Omochumne-Hartnell Water District

OMOCHUMNE-HARTNELL WATER DISTRICT: GROUNDWATER RECHARGE PROJECT

Addendum to the Mitigated Negative Declaration
State Clearinghouse # 2018072026

May 2026

Figure 1
Original and Addendum Project Components

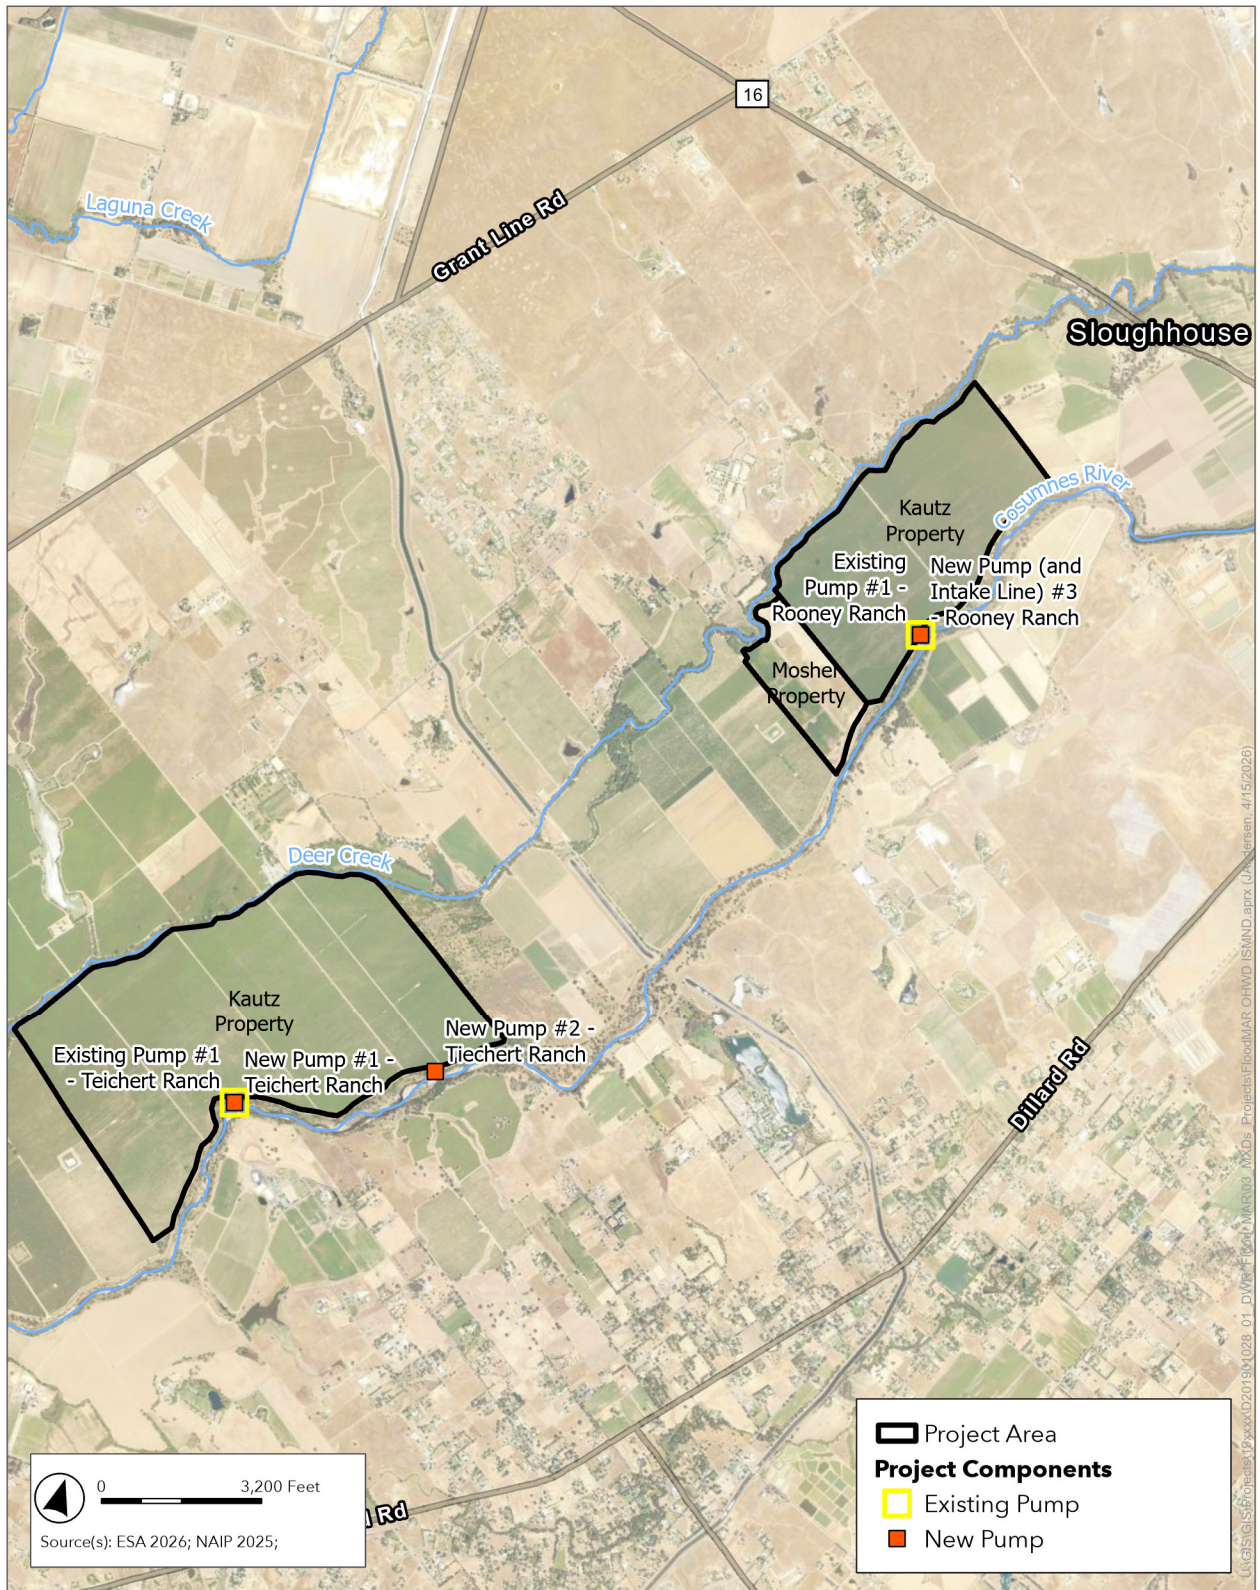
The District is proposing several changes as shown in **Figure 1**. The revised Project would result in the upgrading of the existing pump and the addition of a new pump at Field Site 1 – Teichert Ranch (Kautz Property 1). Another new pump would be constructed at Teichert Ranch, approximately 4,300 feet upstream of Field Site 1. A new pump would also be added at Field Site 2 – Rooney Ranch (Kautz Property 2).

The existing pump station at Teichert Ranch would be upgraded by adding a C78-21TA cone fish screen. The screen unit consists of a conical-shaped wedgewire screen, an external brush cleaning system, and brush drive assembly with controls. The mechanical brushing action prevents debris buildup, sedimentation, biofouling, and increased head loss at the screen.

A new pump would be added to the existing pump station at Teichert Ranch. The second pump at this location would allow a maximum diversion capacity of 4,000 gallons per minute (gpm). Currently, the existing pump cannot reach its flow rate due to pump design. The pump would be placed on a smoothed-out earthen 10x25-foot area. A connection would be made to the existing conveyance pipeline.

A second new pump would be located at Teichert Ranch, approximately 4,300 feet upstream of the existing pump station. This pump would be the same as the pump to be installed at the existing Teichert Ranch site. The pump would be placed on a smoothed-out earthen 10x25-foot area and have a 4,000 gpm capacity. A new intake line would be installed through the levee and a connection would be made to the existing conveyance pipeline.

A third new pump would be added to the Rooney Ranch site at the existing pump station. This pump would be similar to the other new pumps and would also require a new intake line through the levee and connection to the existing conveyance pipeline. The capacity of this pump would be approximately 4,000 gpm.

In total, capacity at Teichert Ranch would increase from 5,000 gpm to approximately 13,000 gpm. Capacity at Rooney would increase from 3,465 gpm to approximately 7,500 gpm. In total, the diversion capacity would increase from approximately 8,345 to 20,500 gpm.
